**ADDENDUM NO. 2**  
**Bid Reference No. MCN.0025**  
**GPR Event ID PE-61100-NONST-2025-000000066**

**PAVING, LIGHTING AND MARKINGS FOR  
RUNWAY 5 EXTENSION**

**Middle Georgia Regional Airport (MCN)**

**Bid Advertisement Date: April 21, 2025**  
**Addendum No. 2 Issue Date: May 09, 2025**

PROPOSED RUNWAY/TAXIWAY ASPHALT PAVEMENT SECTION WITH SELECT FILL

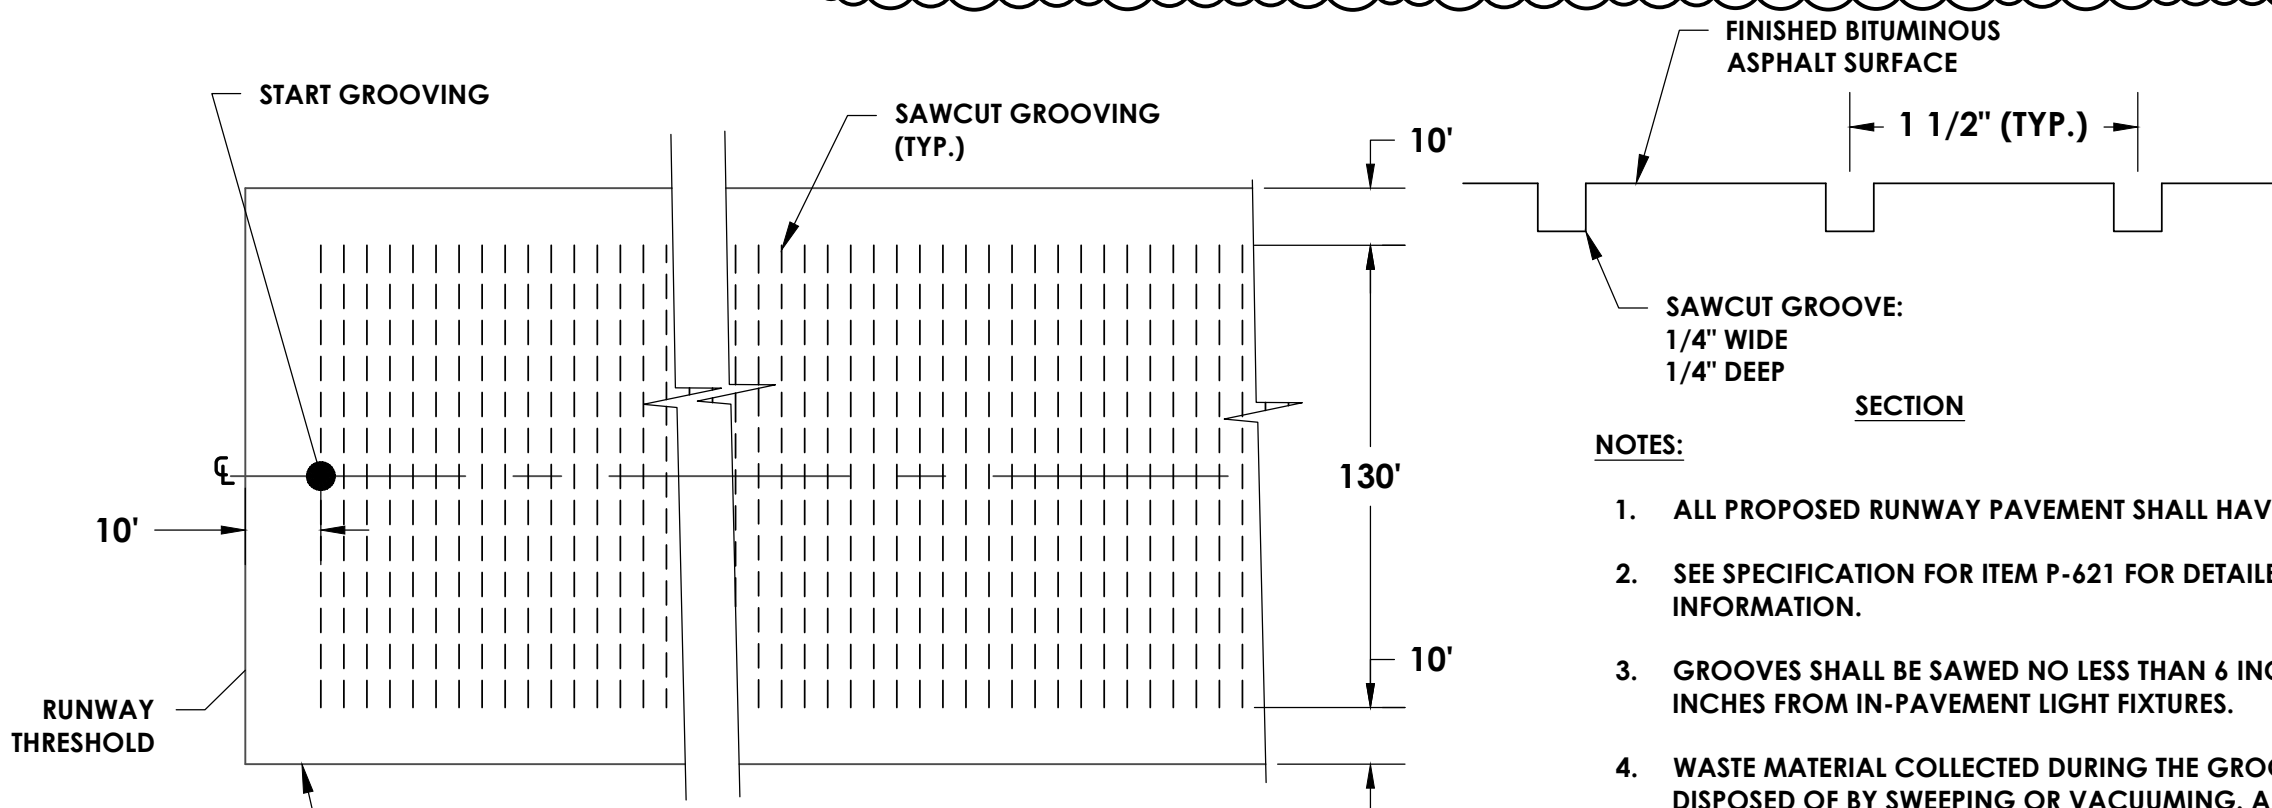
1. The last day for questions has been extended to Monday, May 12 2025 at 5:00 P.M. local time.
2. **Plan Sheet C112.** The "Proposed Runway/Taxiway Asphalt Pavement Section with Select Fill" detail was added.

- CRUSHED AGGREGATE BASE COURSE SHALL HAVE A MINIMUM CALIFORNIA BEARING RATIO (CBR) OF 100, DETERMINED BY LABORATORY TESTING USING SOAKED AND REMOLDED SAMPLES COMPACTED TO AT LEAST 100% OF THE MODIFIED PROCTOR (ASTM D1557) MAXIMUM DRY DENSITY. ALL COSTS ASSOCIATED WITH LABORATORY TESTING SHALL BE INCIDENTAL TO THE "CRUSHED AGGREGATE BASE COURSE (11.5-INCH DEPTH) (MINIMUM CBR OF 100)" PAY ITEM.

- CONTRACTOR SHALL PROVIDE A PAVEMENT BOX EXCAVATION SURVEY FOR ENGINEER APPROVAL BEFORE INSTALLATION OF OFFSITE BORROW. ALL COSTS SHALL BE INCIDENTAL TO THE "PROJECT SURVEY, STAKEOUT AND RECORD DRAWINGS" ITEM OF WORK.

- FOR LIMITS OF CONSTRUCTION OF OFFSITE BORROW, SEE SHEET C122.
- CONTRACTOR IS RESPONSIBLE FOR ALL PERMITS ASSOCIATED WITH THE OFFSITE BORROW. ALL NECESSARY PERMIT COSTS SHALL BE INCIDENTAL TO THE "OFFSITE BORROW" ITEM OF WORK.

- THE CONTRACTOR SHALL PROVIDE LABORATORY TESTING RESULTS VERIFYING THAT ANY OFFSITE BORROW MATERIAL USED TO MEET SUBGRADE REQUIREMENTS ACHIEVES A MINIMUM CALIFORNIA BEARING RATIO (CBR) OF 20, DETERMINED IN ACCORDANCE WITH ASTM D1883, USING SOAKED CONDITIONS AND COMPACTED TO MODIFIED PROCTOR DENSITY PER ASTM D1557. ALL TEST RESULTS SHALL BE SUBMITTED TO THE ENGINEER FOR REVIEW AND APPROVAL PRIOR TO PLACEMENT. ALL COSTS SHALL BE INCIDENTAL TO THE "OFFSITE BORROW" ITEM OF WORK.

SHEET:  
**C114**

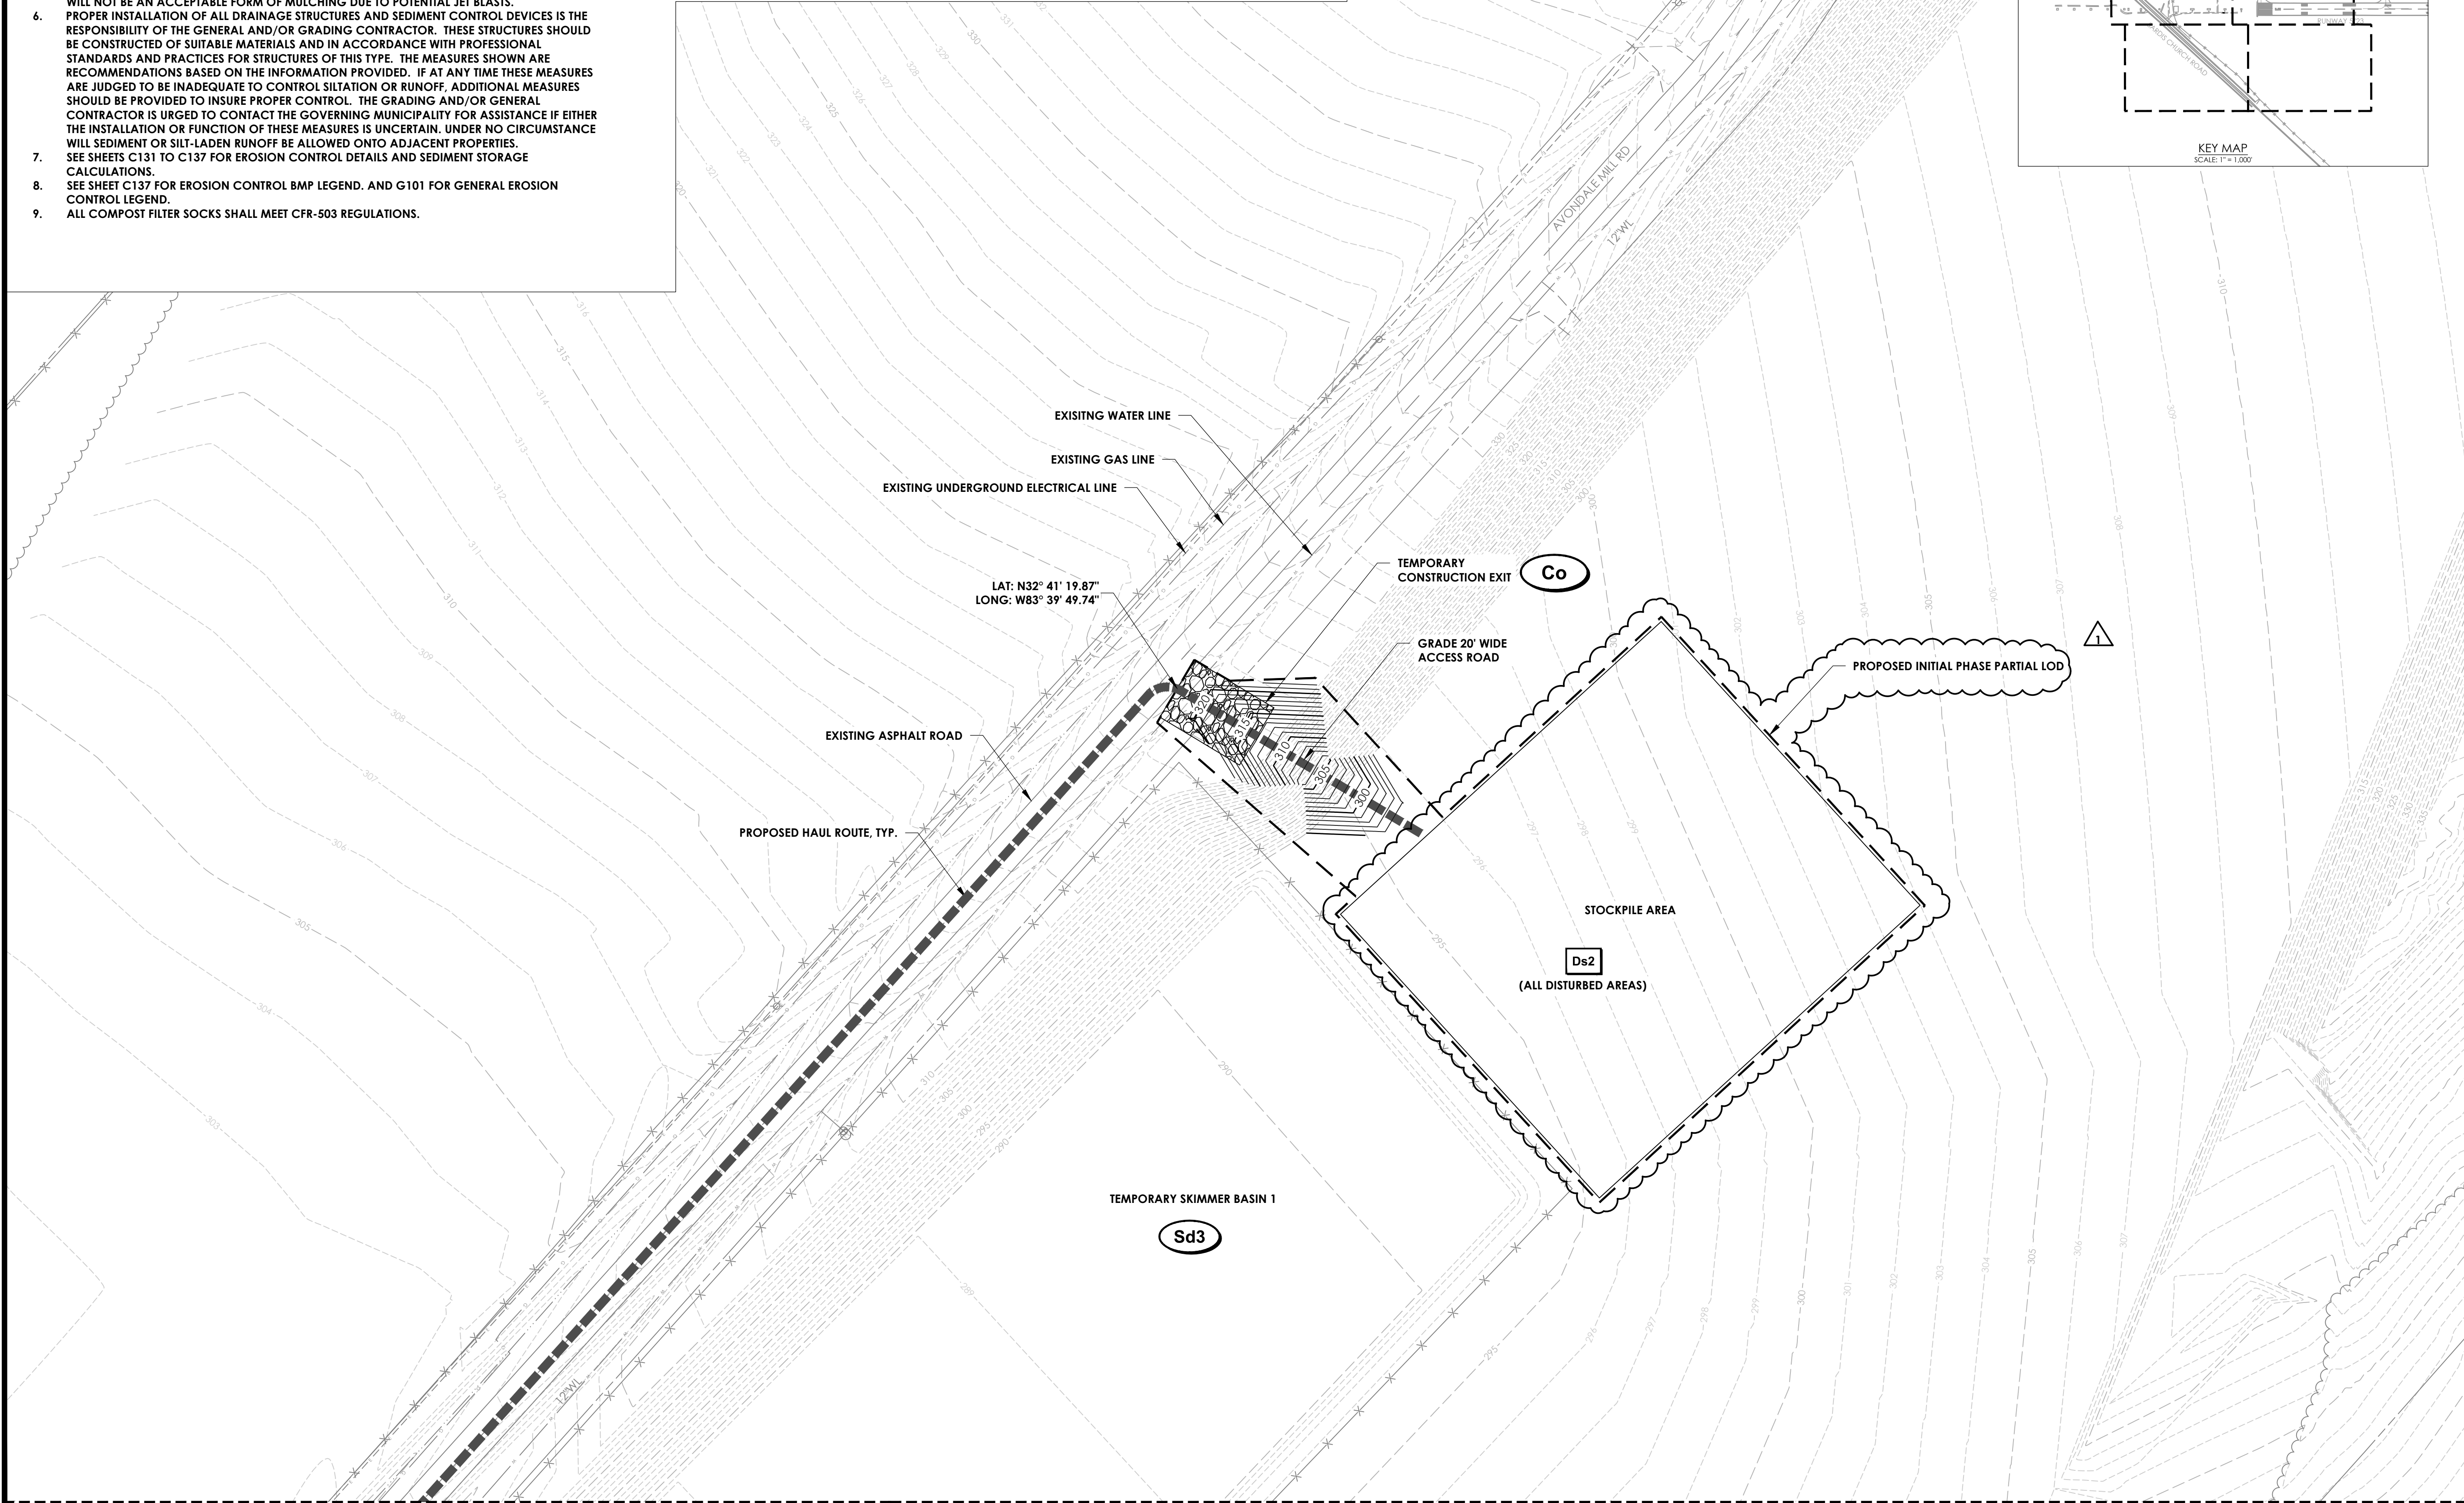
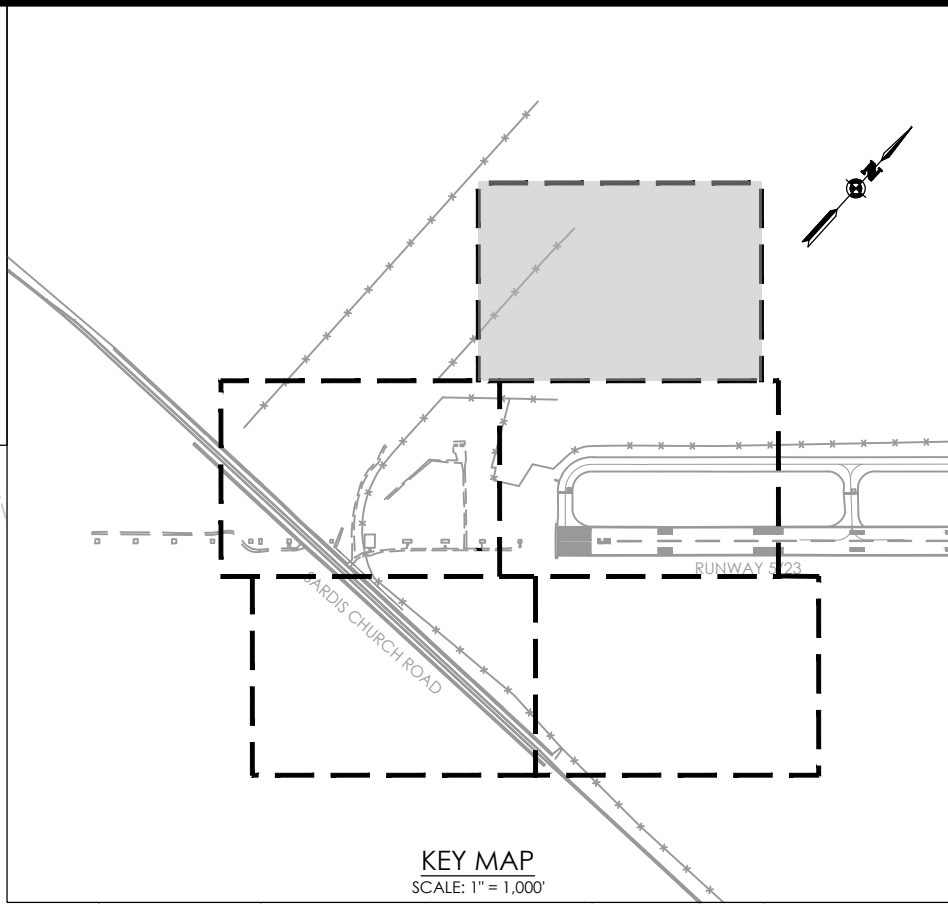
3. **Plan Sheet C114.** The stockpile limits of disturbance was updated to account for additional excavation where offsite borrow material will be installed. The total limits of disturbance notes were updated.

1. INITIAL PHASE BASE BID DISTURBED AREA = 5.14 AC
2. INITIAL PHASE ALTERNATE 1 DISTURBED AREA = 7.73 AC
3. EROSION CONTROL PRACTICES MUST COMPLY WITH THE STANDARDS AND SPECIFICATIONS IN THE "MANUAL FOR EROSION AND SEDIMENT CONTROL IN GEORGIA", LATEST VERSION.

SHEET:  
**C120**

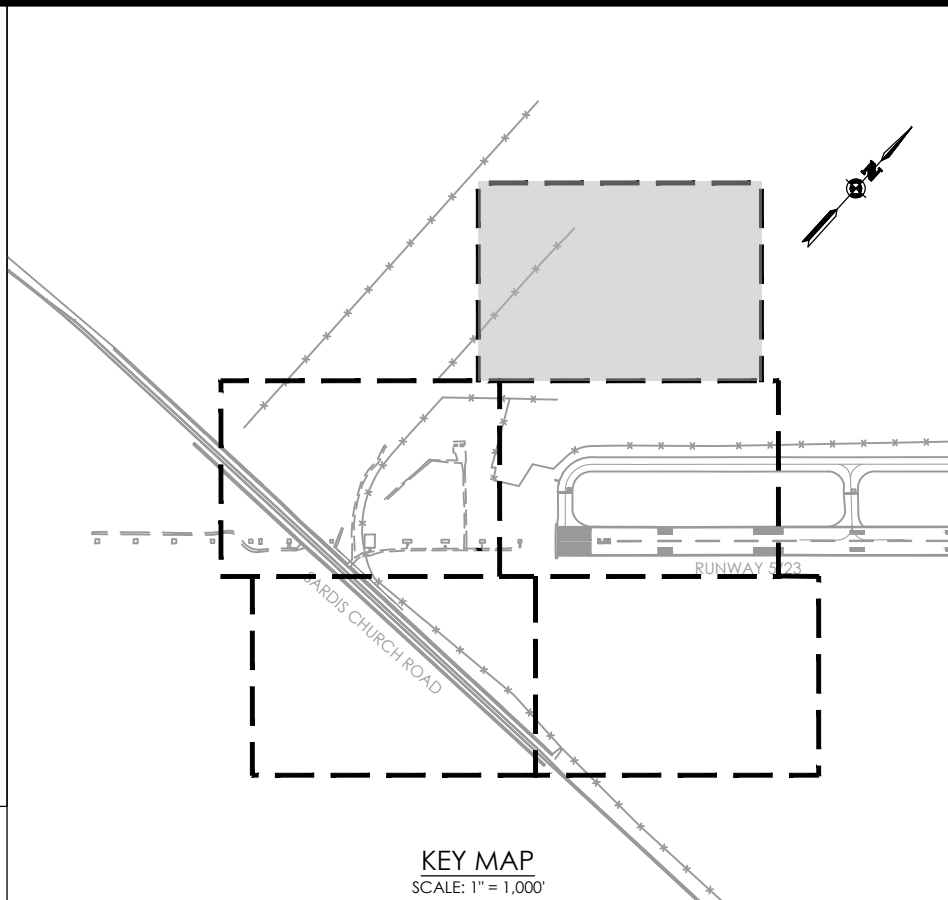
5. **Plan Sheet C120.** The stockpile limits of disturbance and grades were updated to account for additional excavation where offsite borrow material will be installed. The total limits of disturbance notes were updated.

SHEET:  
**C145**

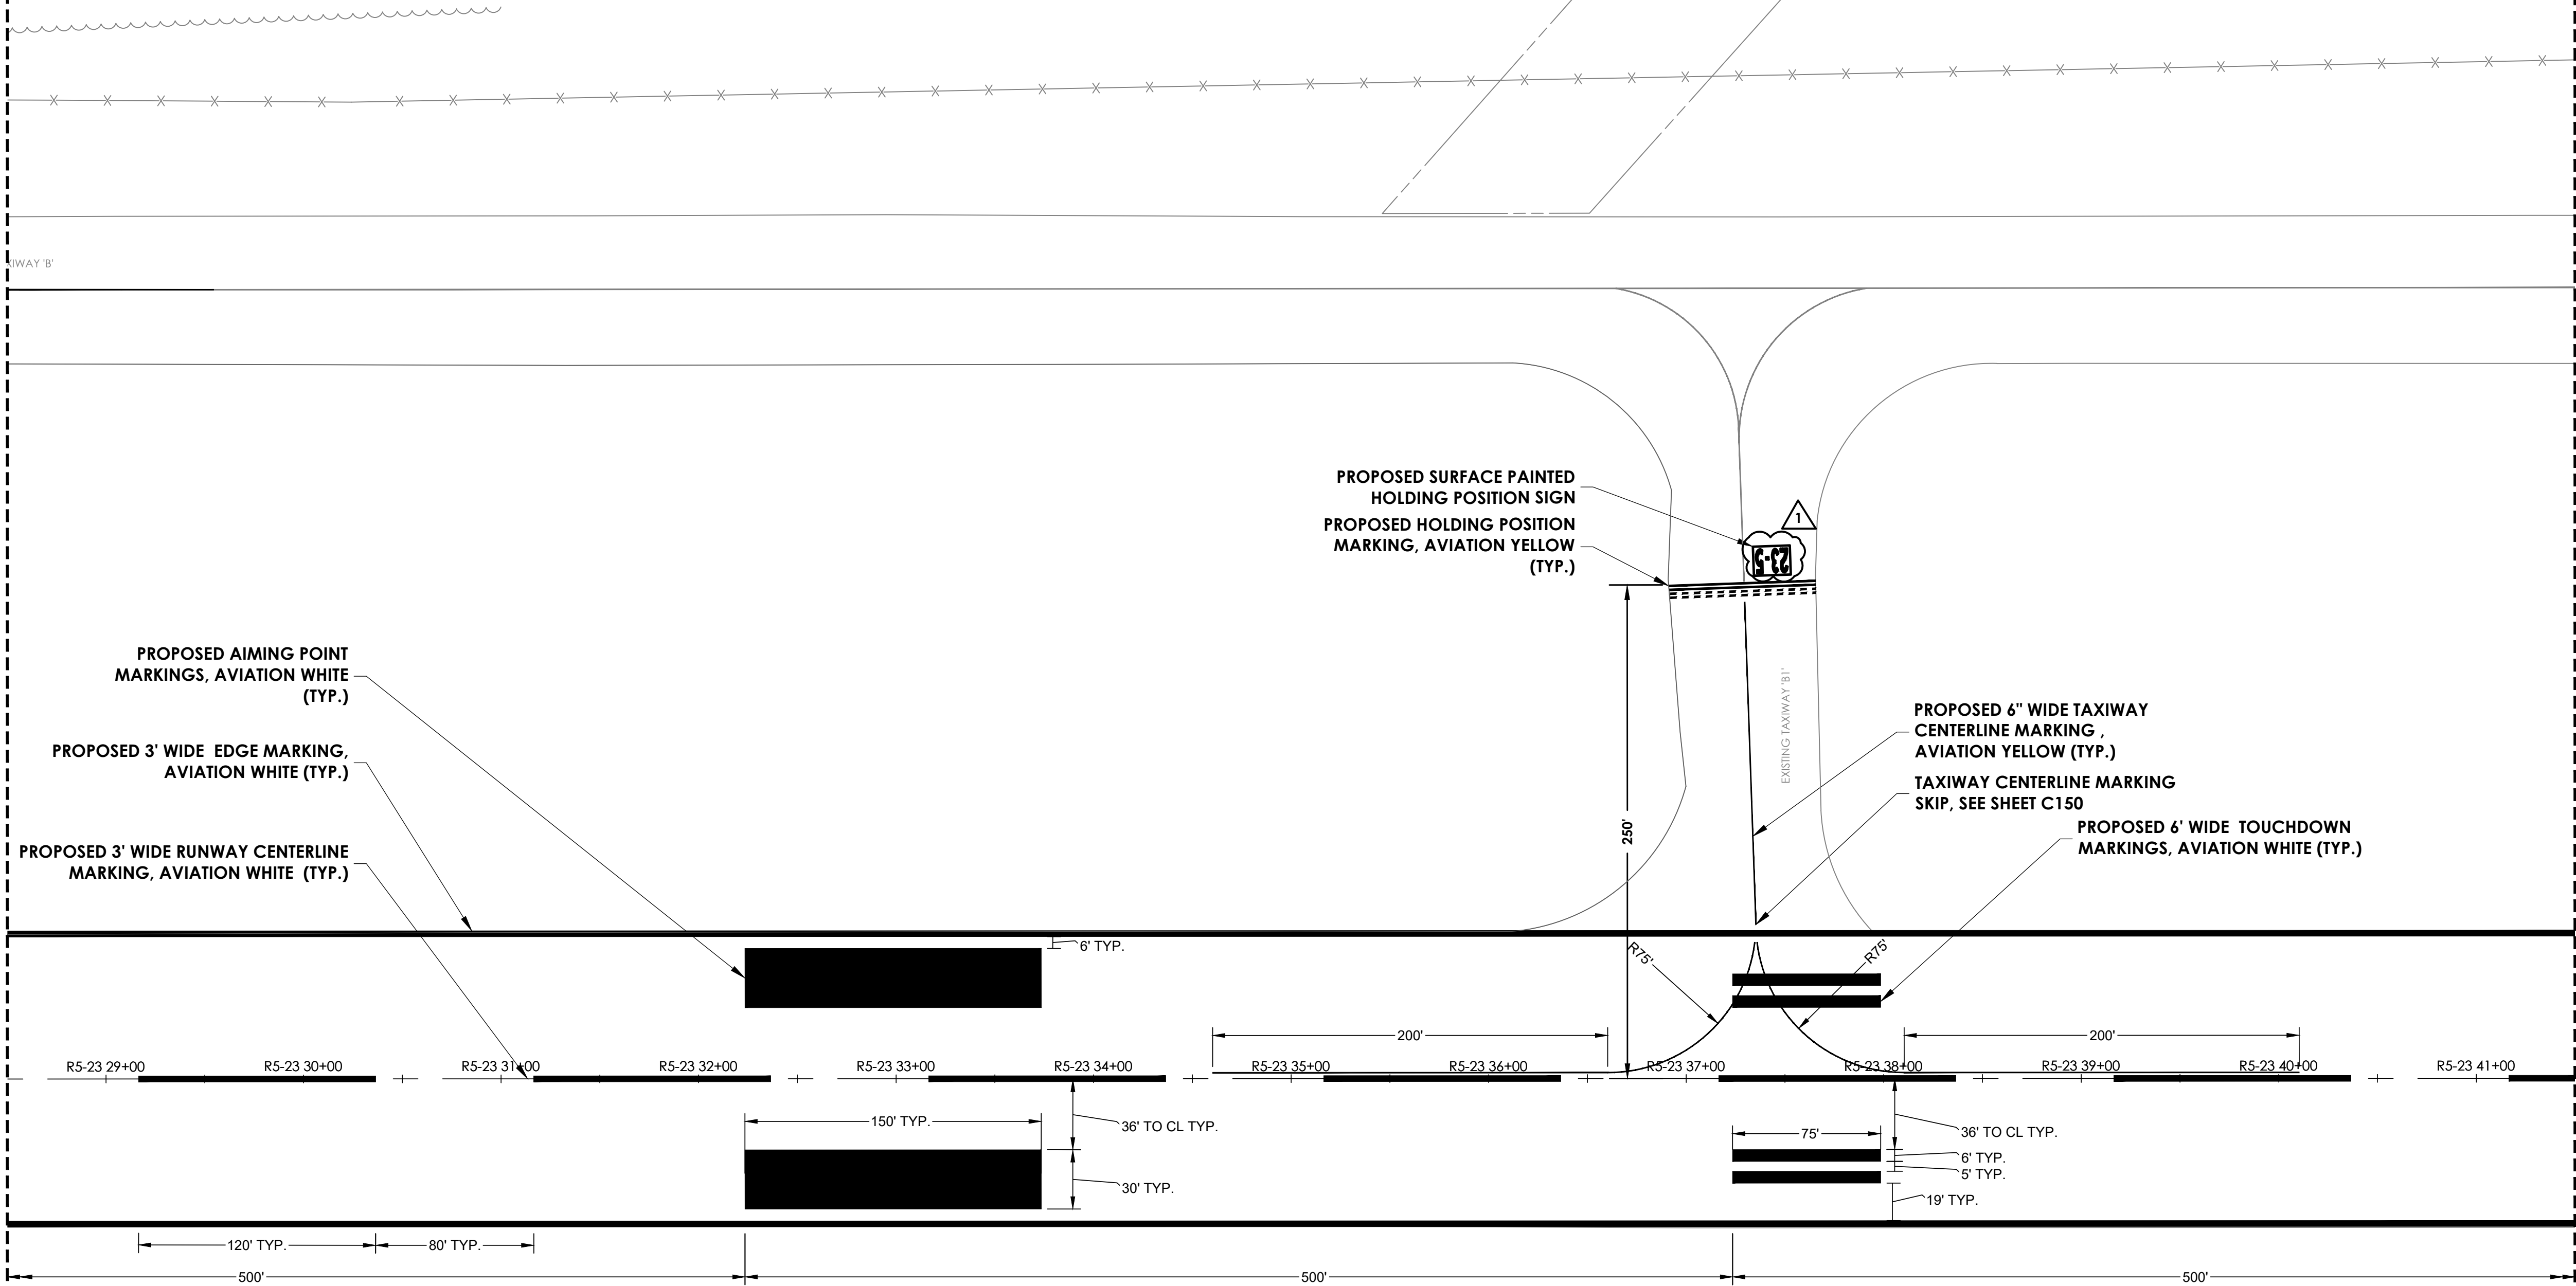
9. **Plan Sheets C144, C145, C147 and C149.** The proposed runway designation was changed from "6-24" to "5-23". Runway designation markings and surface painted holding position signs were updated.
